CITY OF MADISON
CITY ENGINEERING DIVISION
DEPARTMENT OF PUBLIC WORKS
PLAN OF PROPOSED IMPROVEMENT

N FRANKLIN AVENUE & LYNN TERRACE -
ASSESSMENT DISTRICT 2025
CITY PROJECT NO. 15113
CONTRACT NO. 8766

ADDENDUM 1 - 02/11/25
UPDATED SHEETS: D5-D10,
PD1-PD5, P1-P6, X1-X13

REVISION 1 - 04/03/25
UPDATED SHEETS: COVER,
D6, PD1-PD3, P1-P3, U1-U9,
W1-W9, X3-X11
SHEET ADDED: U10

15113		DETAILS - CHAMBERLAIN AVE INTERSECTION GRADES	15113
N FRANKLIN AVENUE & LYNN TERRACE - ASSESSMENT DISTRICT 2025		MADISON, WI	
M:\DESIGN\Projects\15113\CAD\Streets\15113EN-PHP.dwg		CONTRACT NO: 8766	
15113		D-6

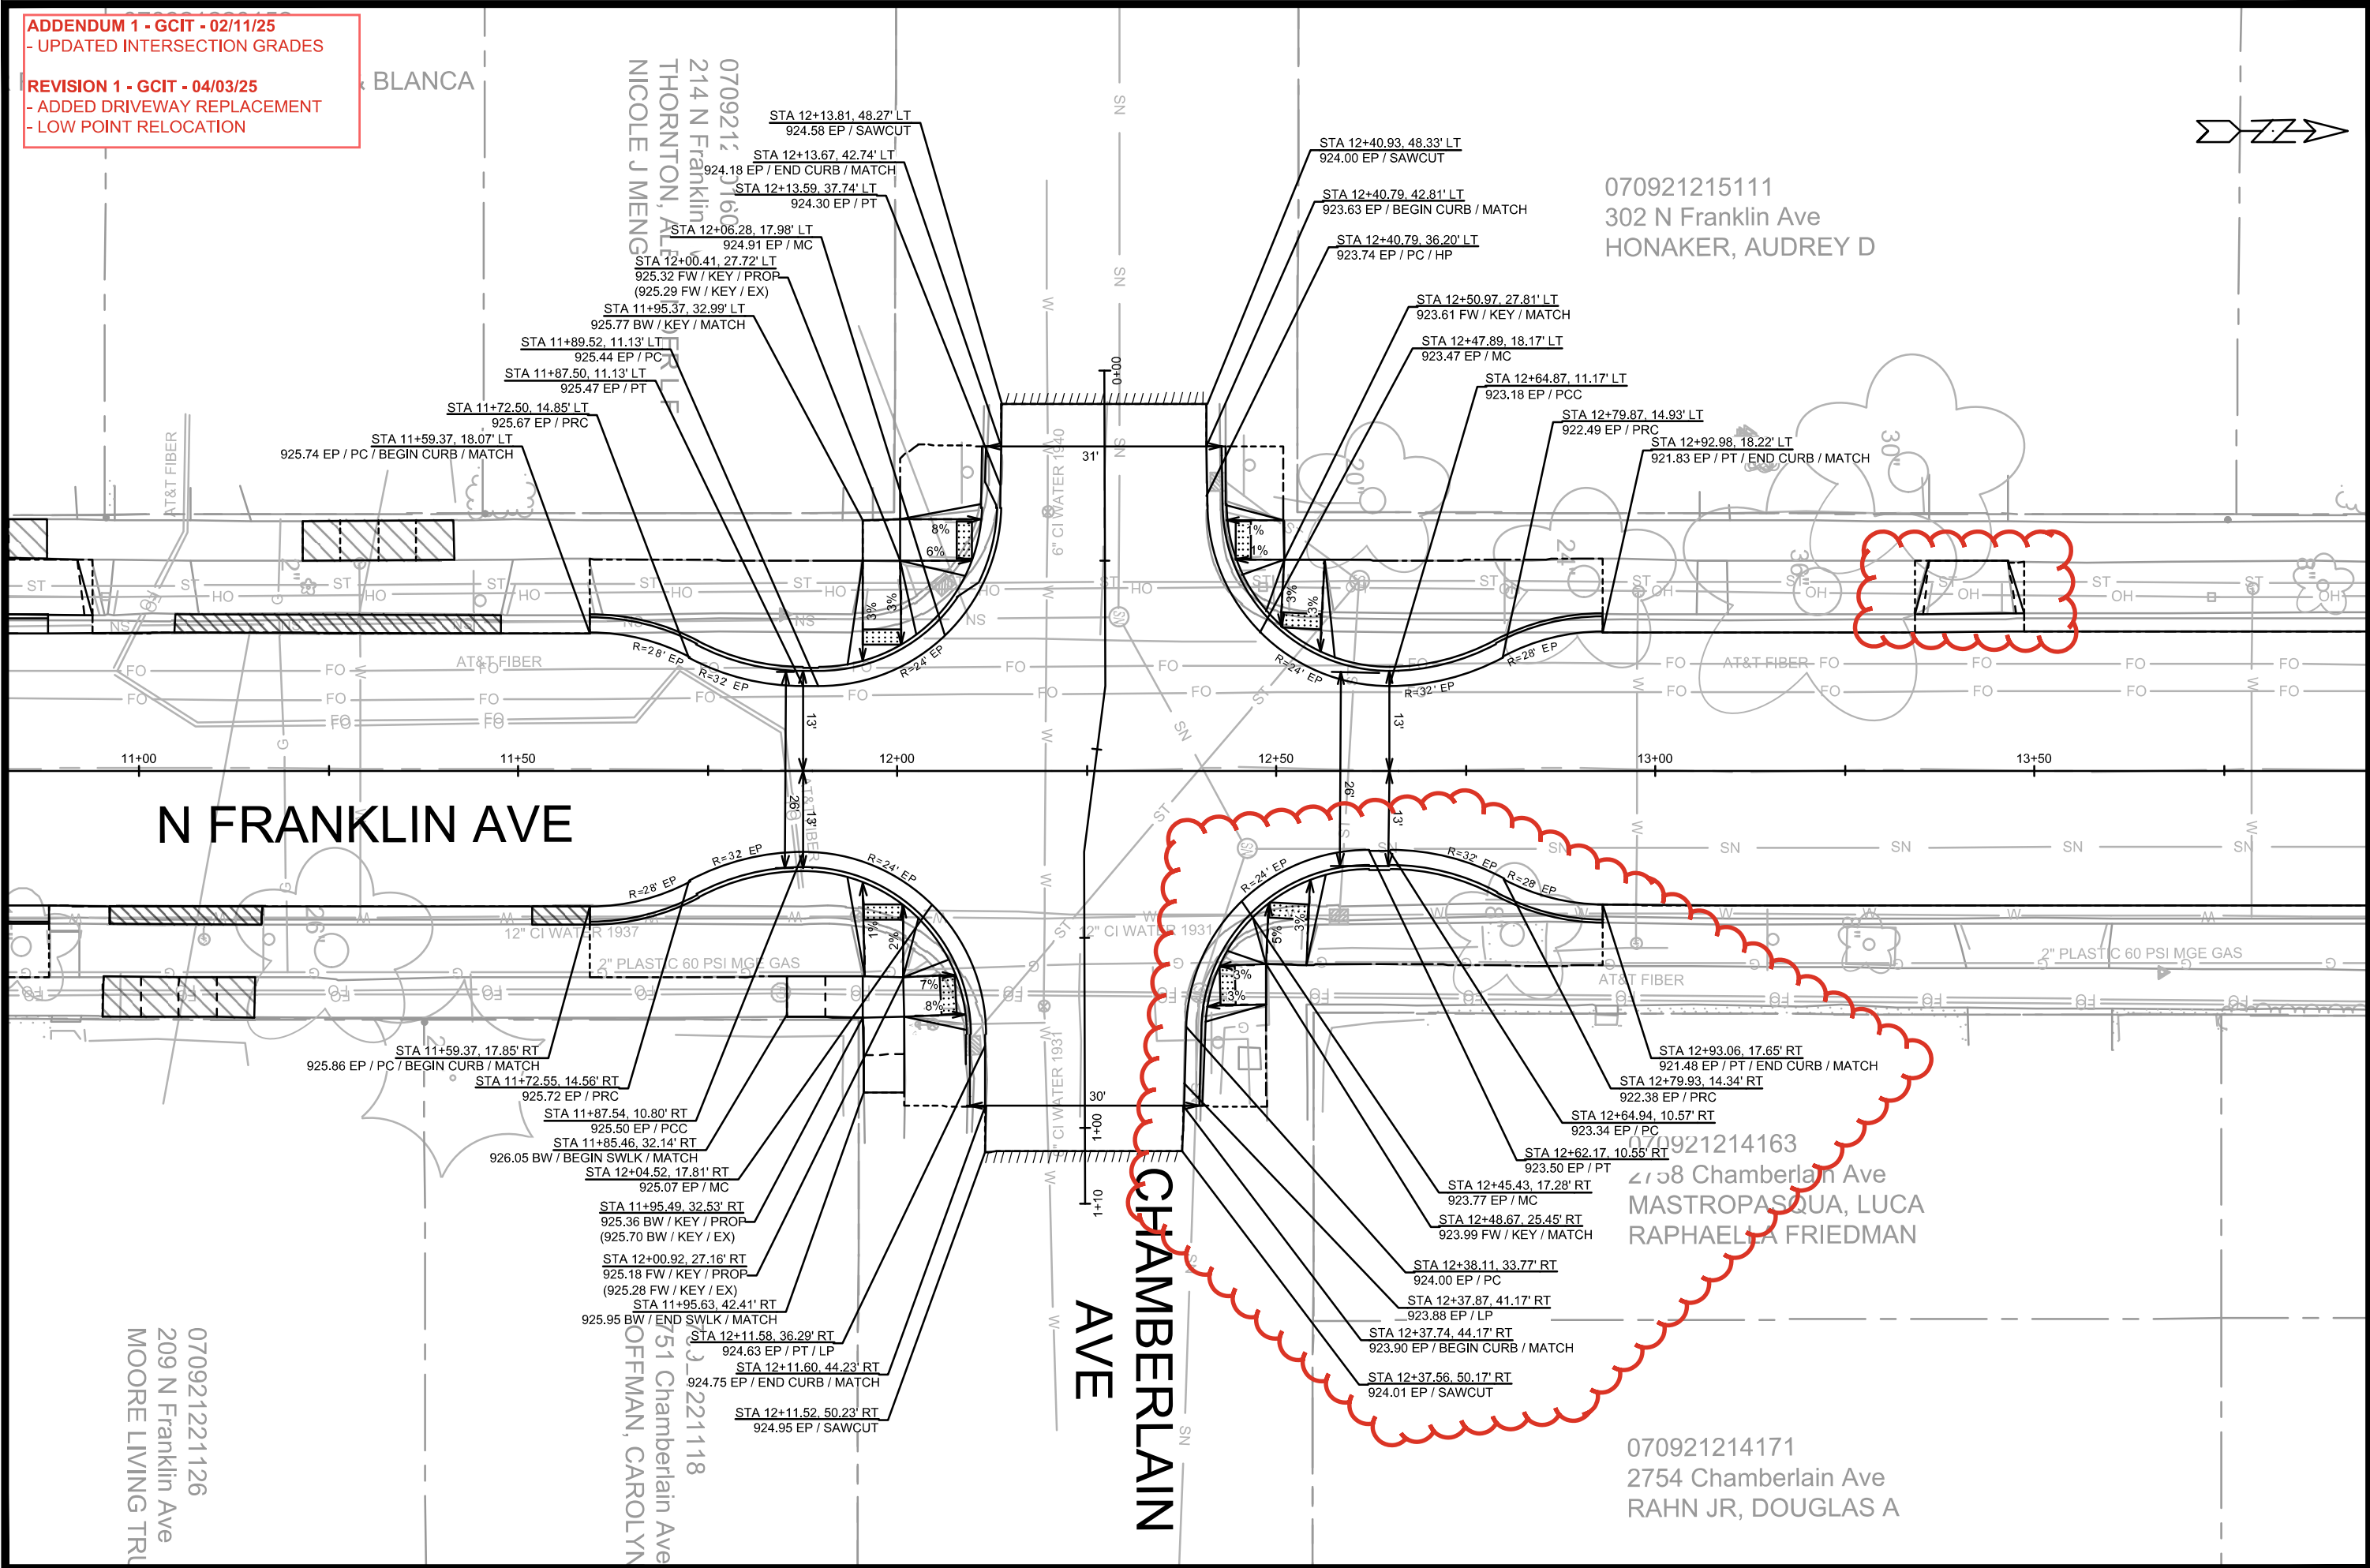
REVISION 1 - GCIT - 04/03/25
- ADDED DRIVEWAY REPLACEMENT
- LOW POINT RELOCATION

ADDENDUM 1 - GCIT - 02/11/25

- UPDATED INTERSECTION GRADES

15113		15113		15113	
N FRANKLIN AVENUE & LYNN TERRACE - ASSESSMENT DISTRICT 2025		MADISON, WI		15113	
CONTRACT NO:		8766		15113	
M:\DESIGN\Projects\15113\CAD\Sewers\15113SWR-ErosionControl.dwg		Date: 1/22/2025 7:42 AM		Scale: 1" = 40'	
BY		REVISION		BY	
DATE		DATE		DATE	
EC-6		EC-6		EC-6

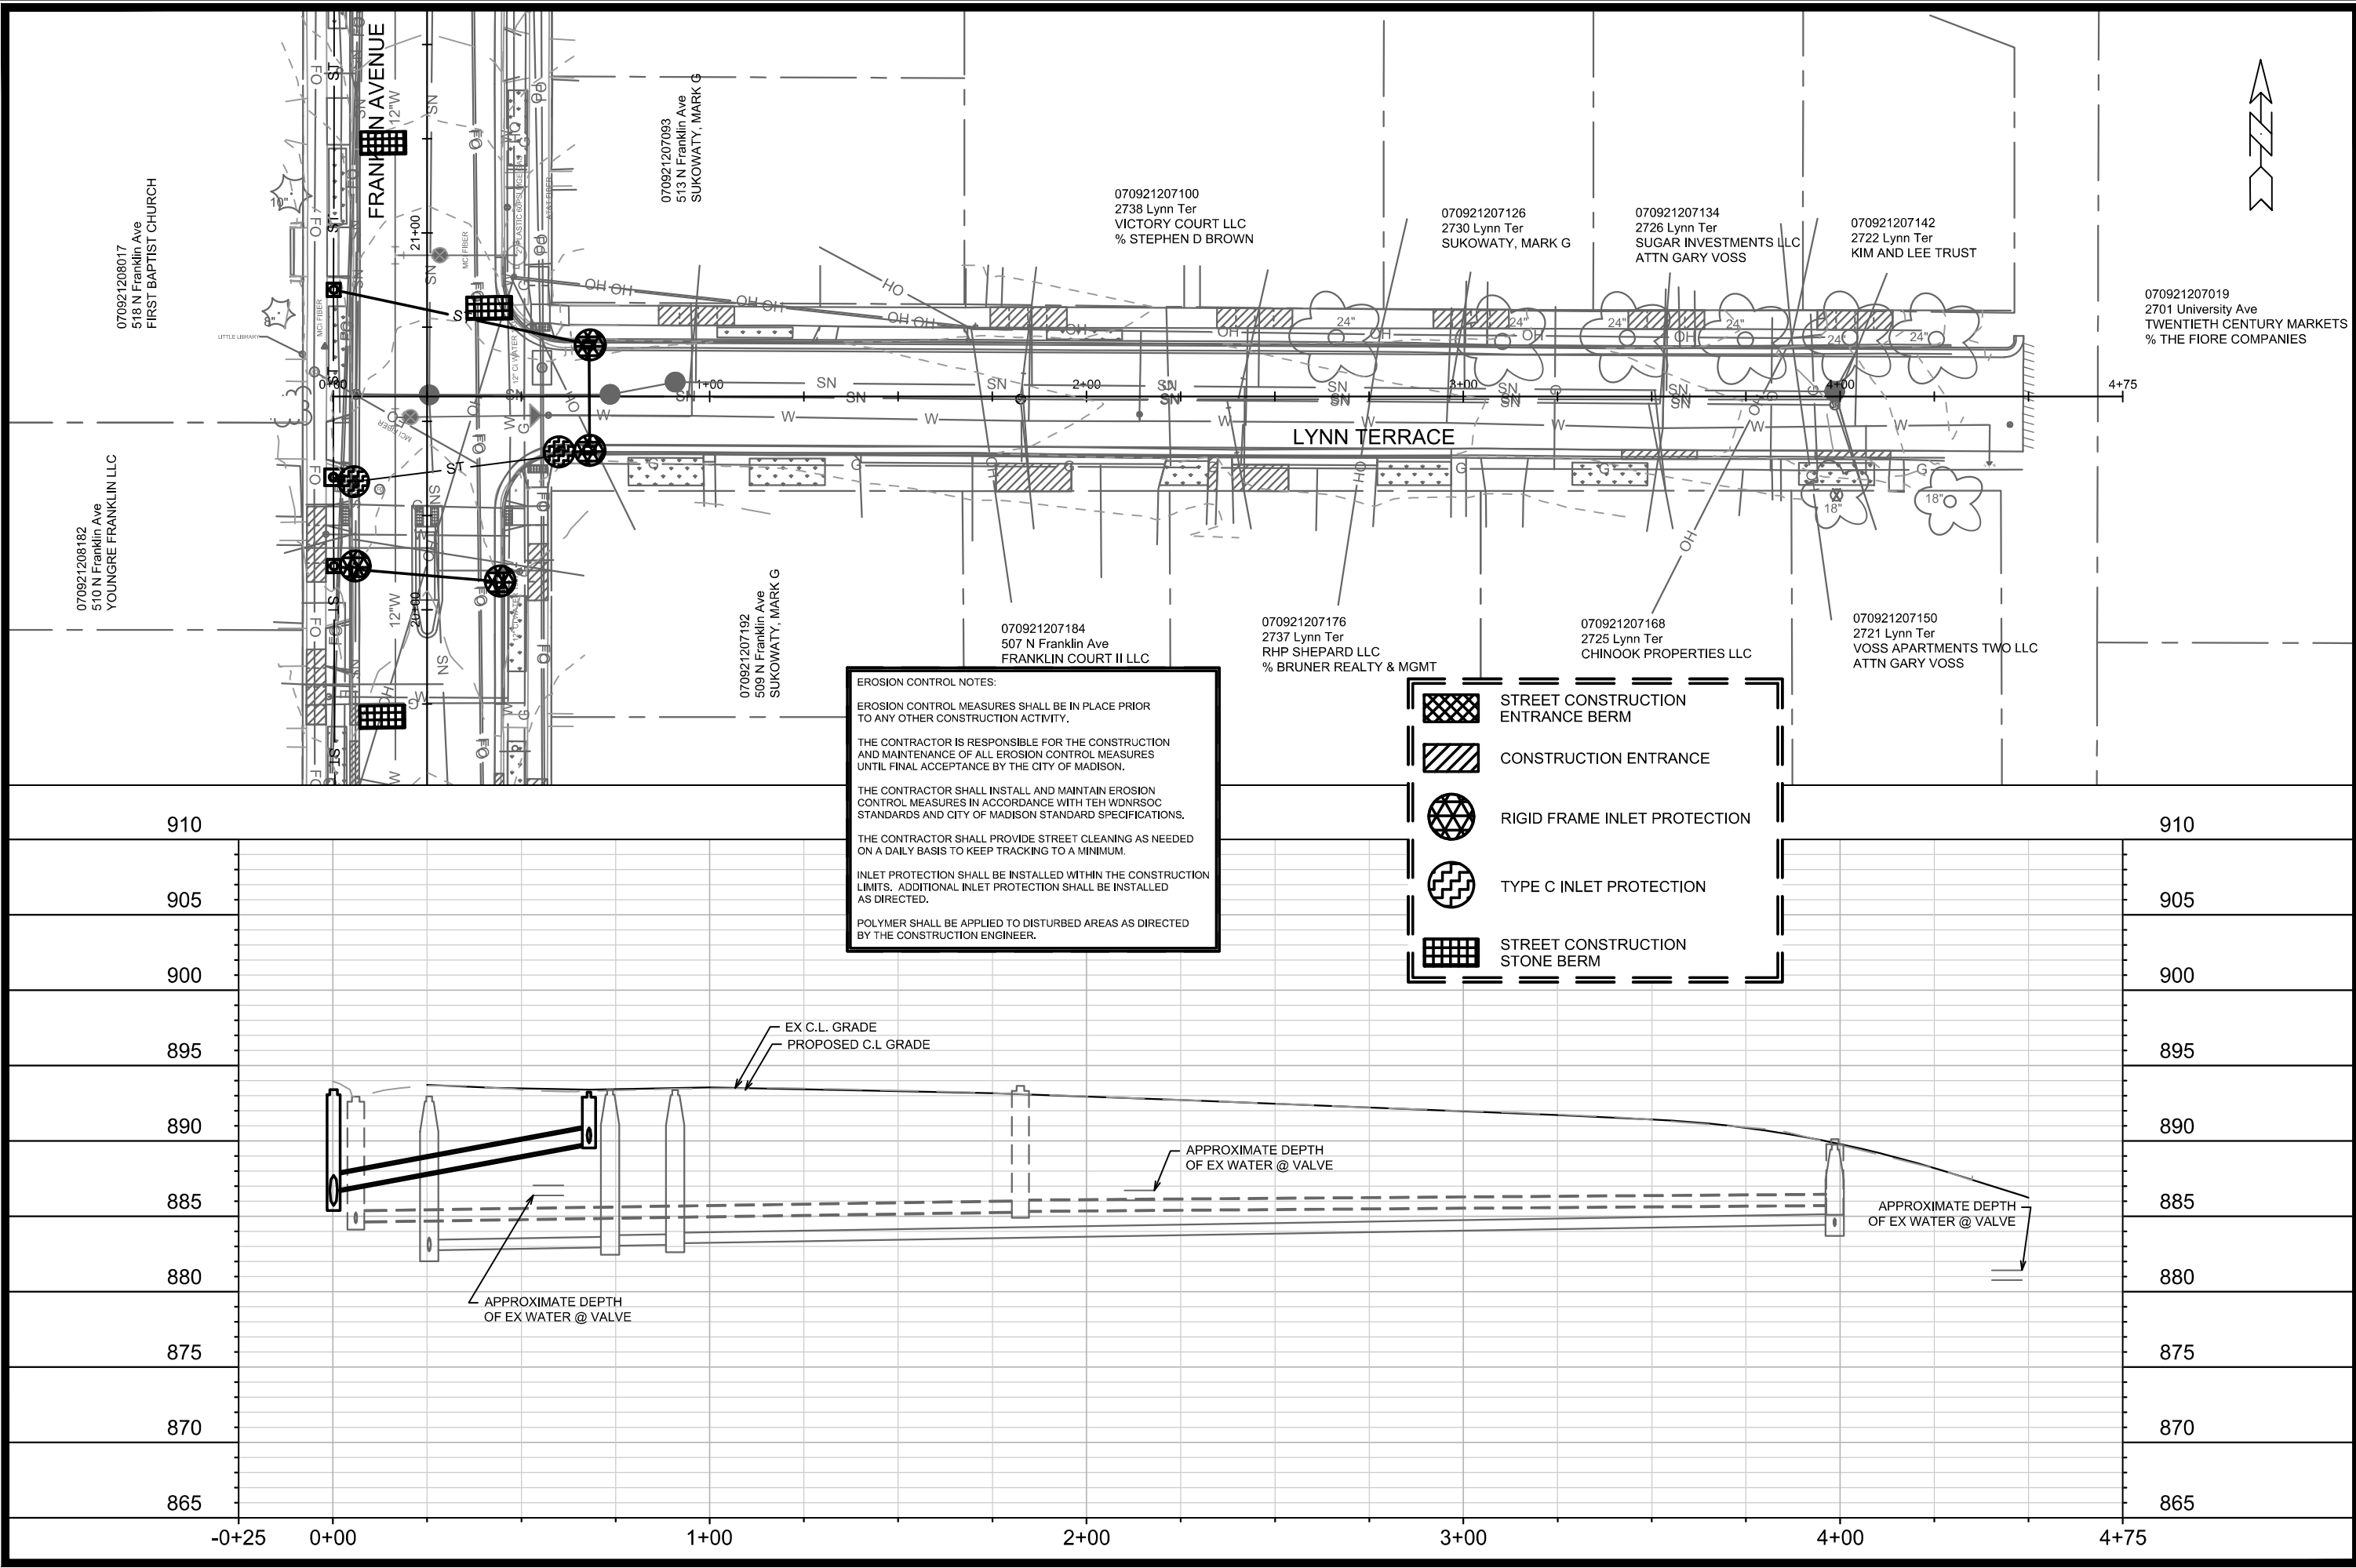
ADDENDUM 1 - GCIT - 02/11/2025
- REVISED TERRACE EXCAVATION SITES

REVISION 1 - GCIT - 04/03/2025
- REPRINTED TO SHOW UPDATED UNDERGROUND UTILITY LOCATION

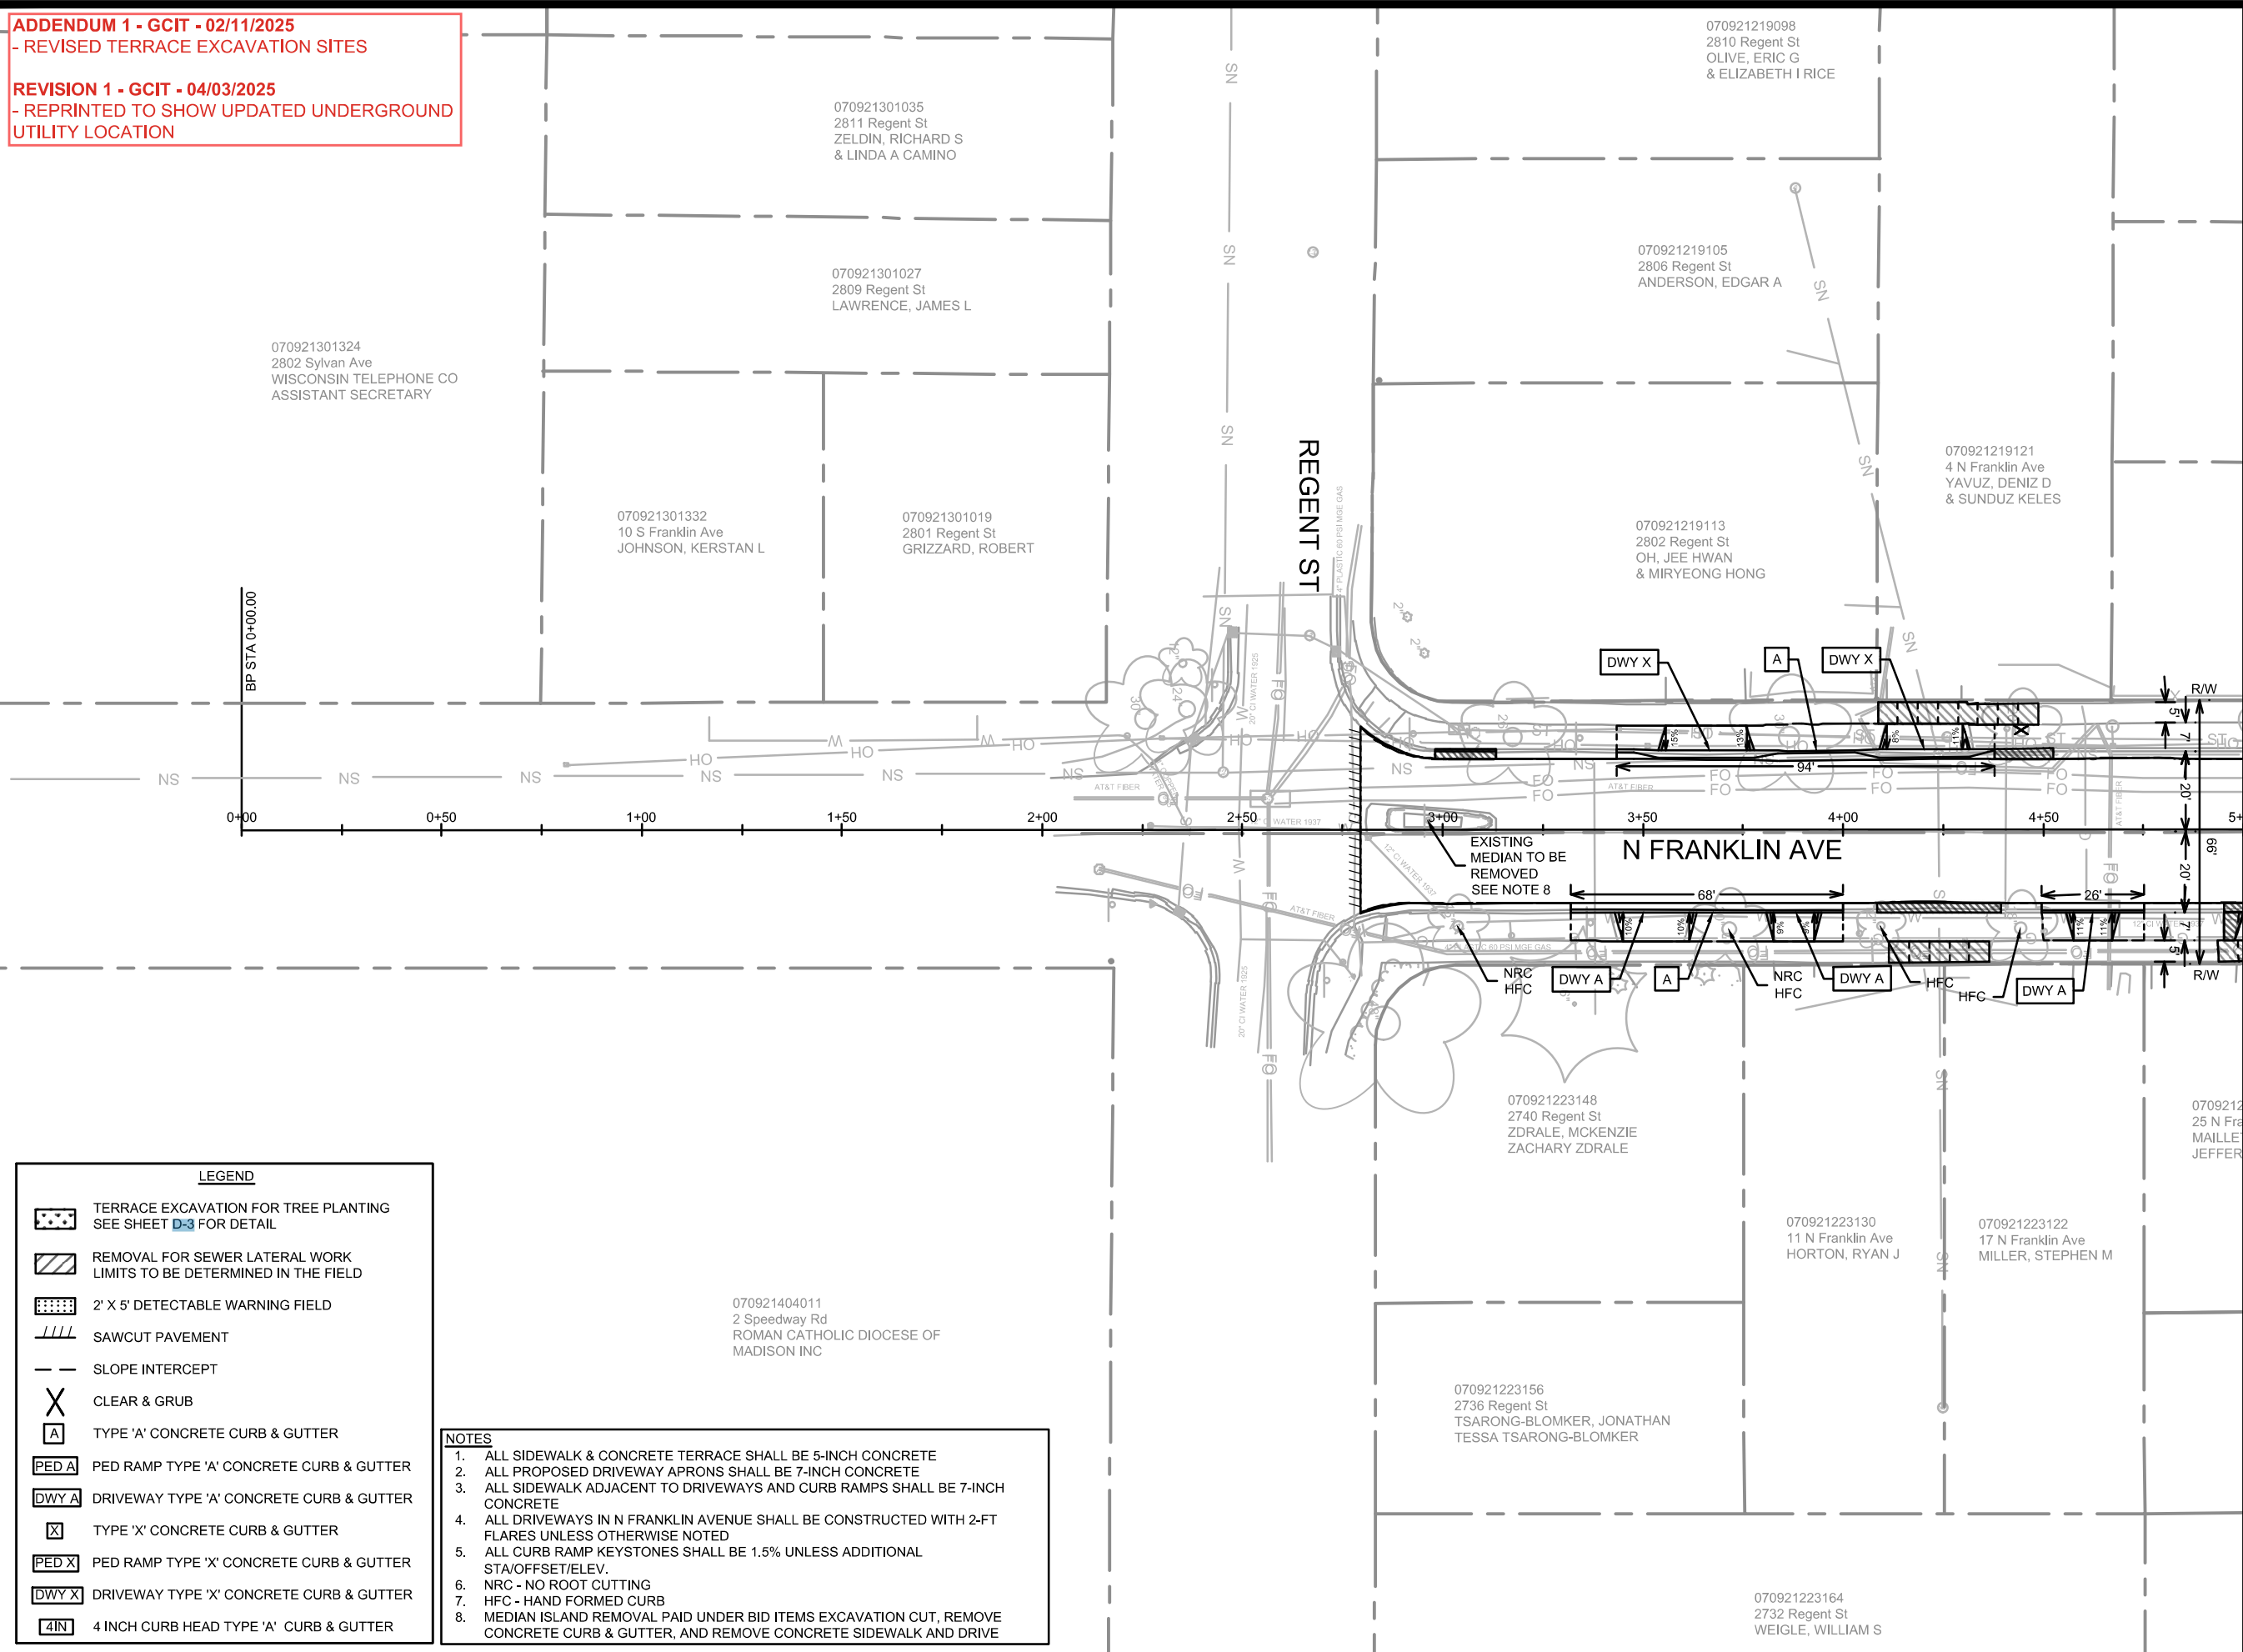
ADDENDUM 1 - GCIT - 02/11/2025
- REVISED TERRACE EXCAVATION SITES

REVISION 1 - GCIT - 04/03/2025
- UPDATED CURB REPLACEMENT LIMITS
